**FINAL ENVIRONMENTAL
IMPACT STATEMENT**

**NEW YORK STATE
DEPARTMENT OF ENVIRONMENTAL CONSERVATION**

**NEW YORK
STATE POLLUTANT DISCHARGE ELIMINATION SYSTEM
(SPDES) PERMITS**

**ROSETON 1 & 2, BOWLINE 1 & 2
AND INDIAN POINT 2 & 3
STEAM ELECTRIC GENERATING STATIONS,
ORANGE, ROCKLAND AND WESTCHESTER COUNTIES**

Fig. 4. Entrainment Probability at Low Flow¹²²

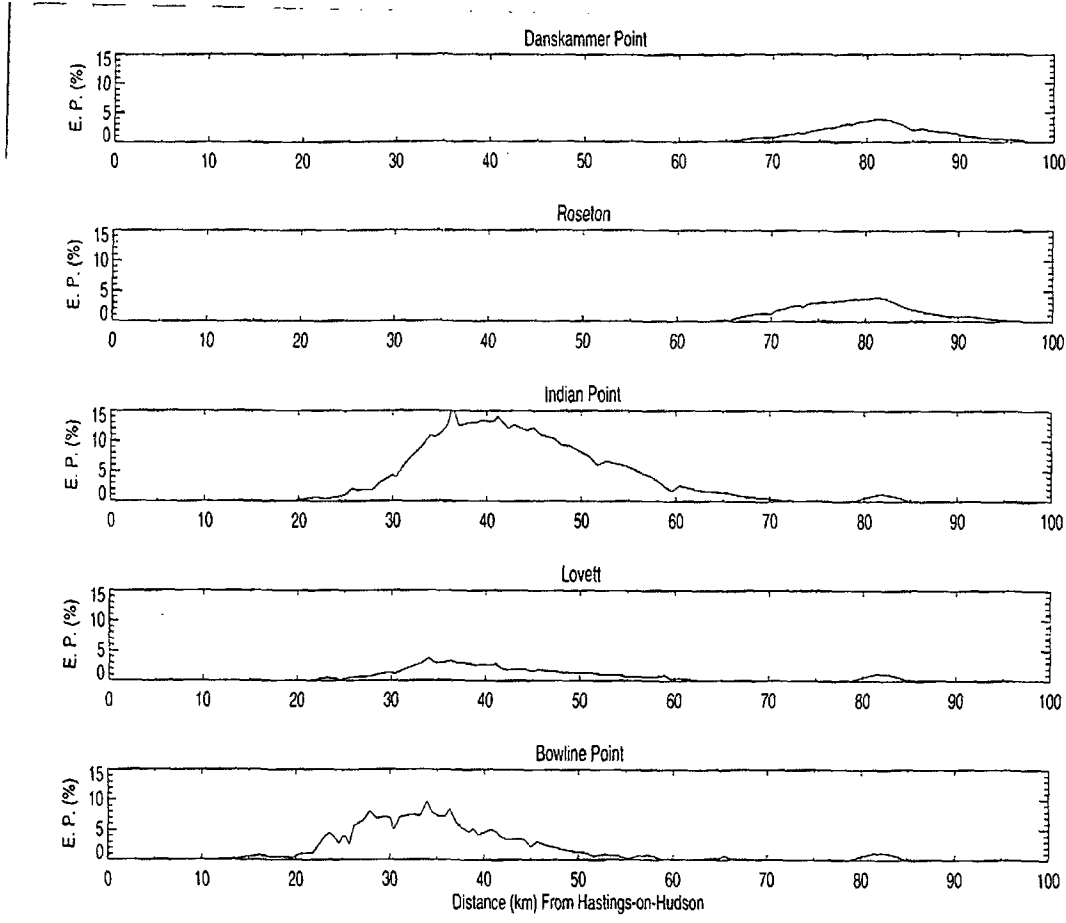
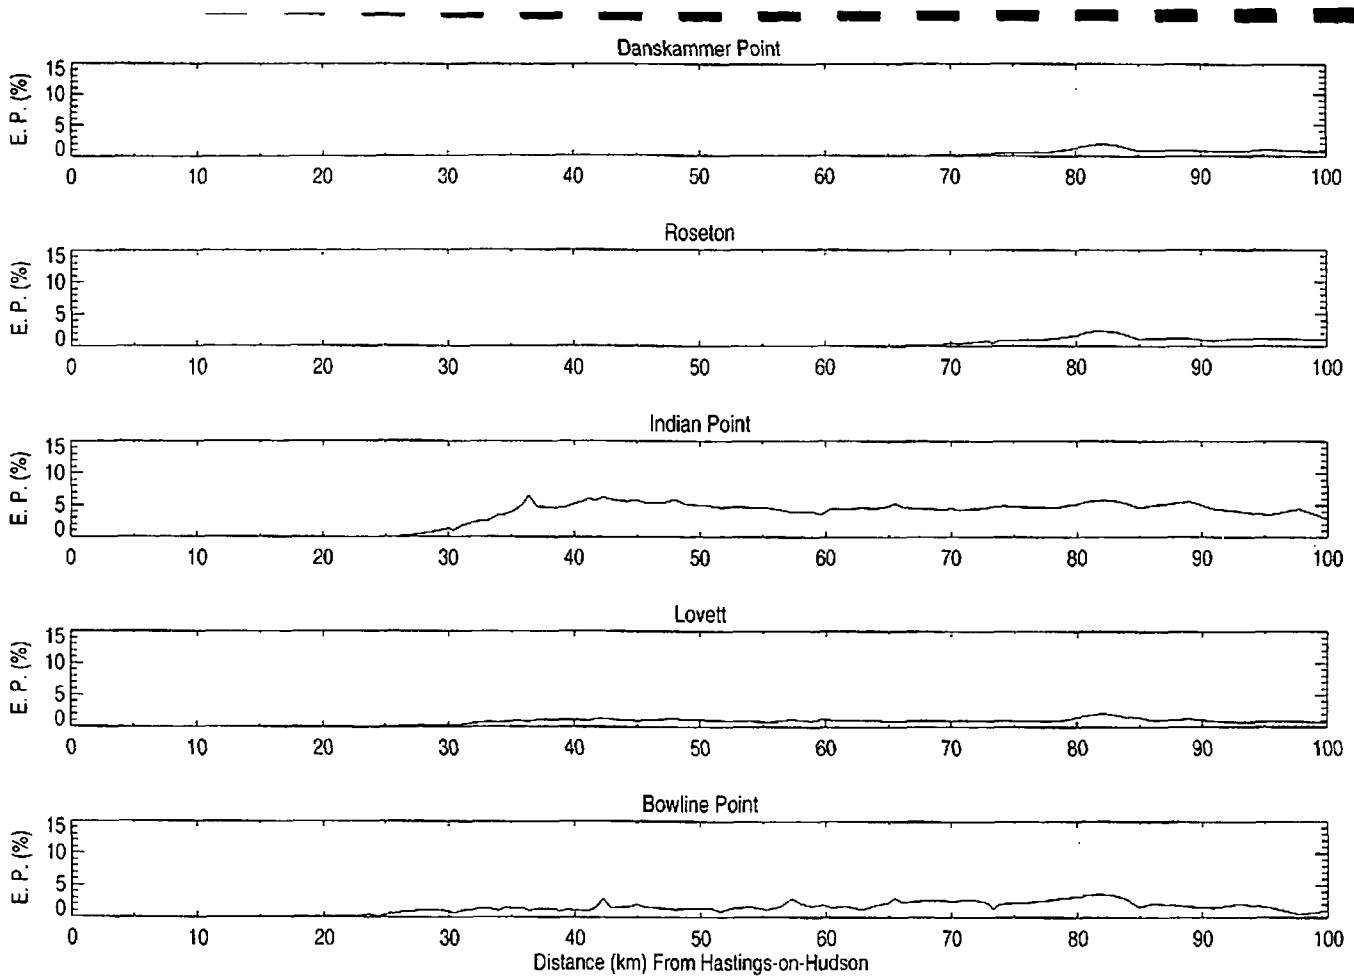
The actual draw-down is likely even greater because the three HRSA generating plants (combined with other facilities in the same river reaches) act cumulatively on the entire aquatic community; many organisms live in this reach of the River for more than seven days; and any organisms coming from upstream, such as tomcod, would also be subject to the draw-down from the Danskammer and Lovett Stations (located in the same river reach but not part of the HRSA nor the subject of this FEIS; see Fig. 2 at end of Regulatory Setting). The most important effect of drawdown is that it dramatically reduces food availability within the ecosystem and, thus, survivability of multiple species over significant stretches of the Hudson River.

Fig. 6. Temperature Profile of the Hudson River, NYC to Newburgh, During a Spring Tide¹⁸⁰

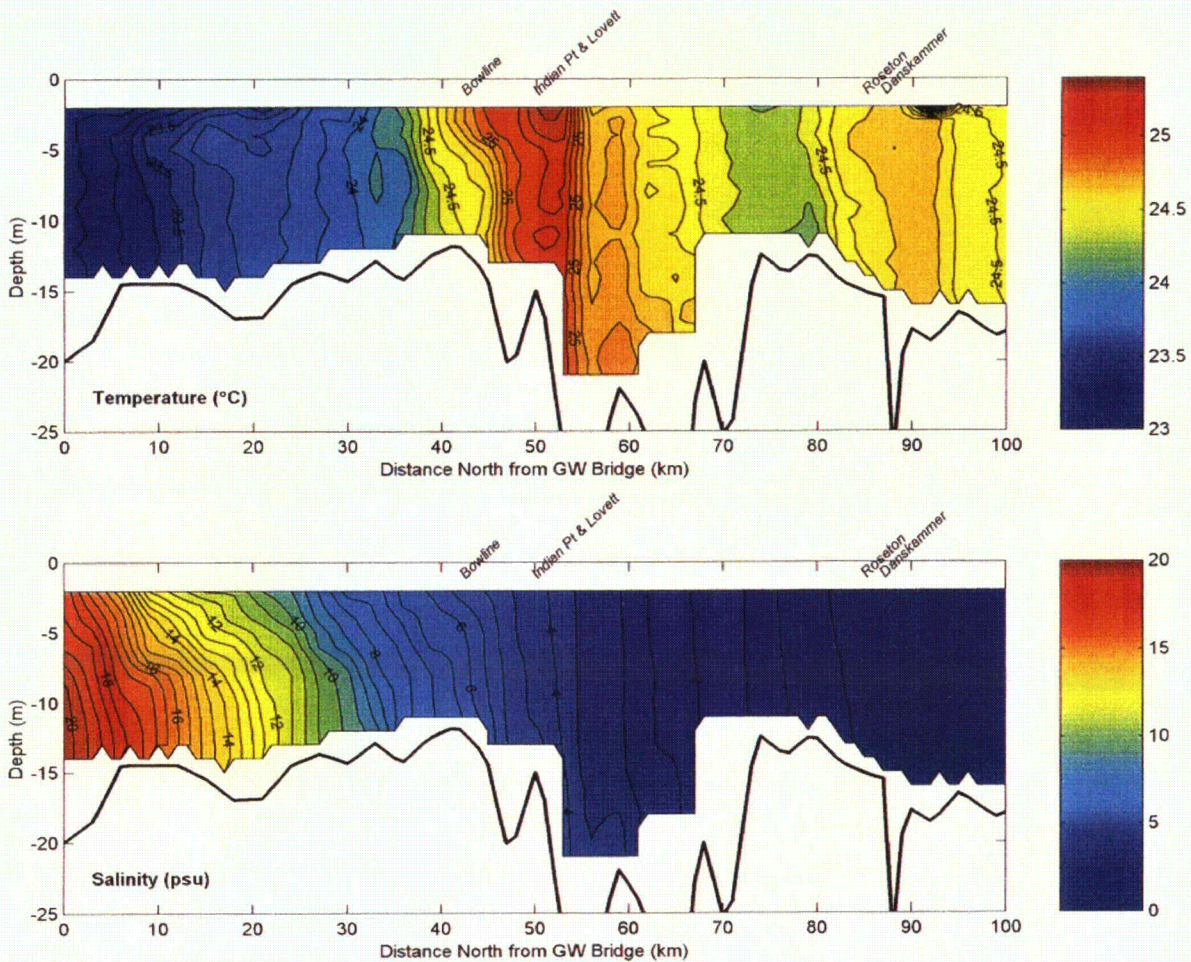
Some graphics and imagery effectively illustrate the basis for the Department's concerns. A study by HydroQual, Inc., examined passive particle movement and also investigated thermal and salinity profiles in several river reaches, including the portion of the Hudson River where the HRSA plants are located.¹⁷⁸ Figures 6 and 7 of this FEIS (following pages), excerpted from that study, show two vertical temperature profiles of the Hudson River from NYC to just above the northernmost of the HRSA plants, one during a spring and the other during a neap tide. Based on these representations, it appears that there may be times and conditions where effluent-warmed waters occupy nearly the entire vertical water column.

**Fig.8. Thermal Plumes from Indian Point, Unit 3,
and Lovett Station, Tompkins Cove, Hudson River, New York State.**

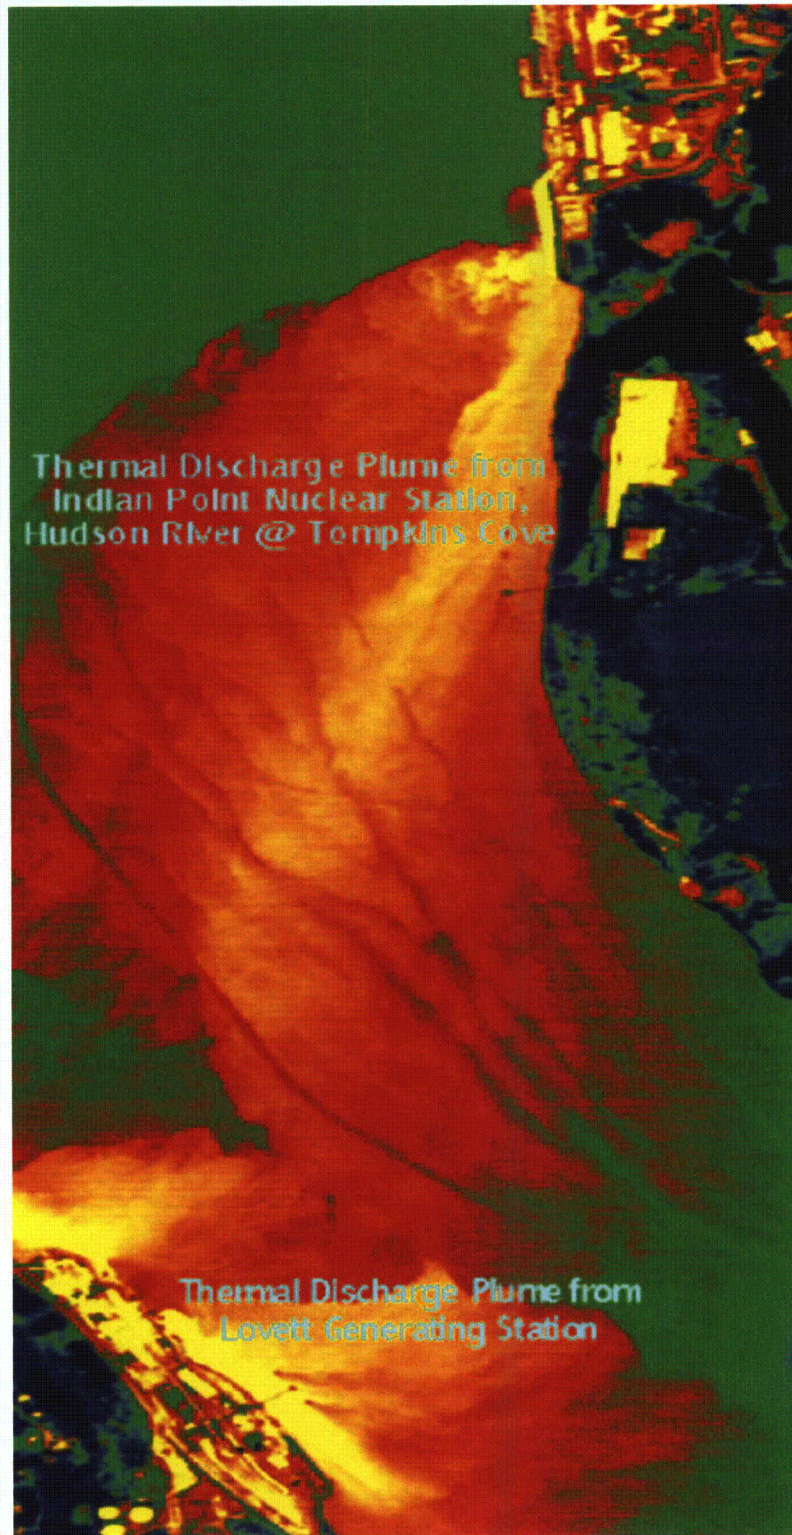
The surface extent of thermal discharges from the HRSA plants is also a concern. Figure 8 is an aerial thermal image of the plume from Indian Point, Unit 3 only, on the east side of the Hudson plus the smaller plume from Lovett on the west bank.¹⁷⁹ In this image, the two plumes came very close to meeting on the surface, even with Indian Point running at less than its full capacity.
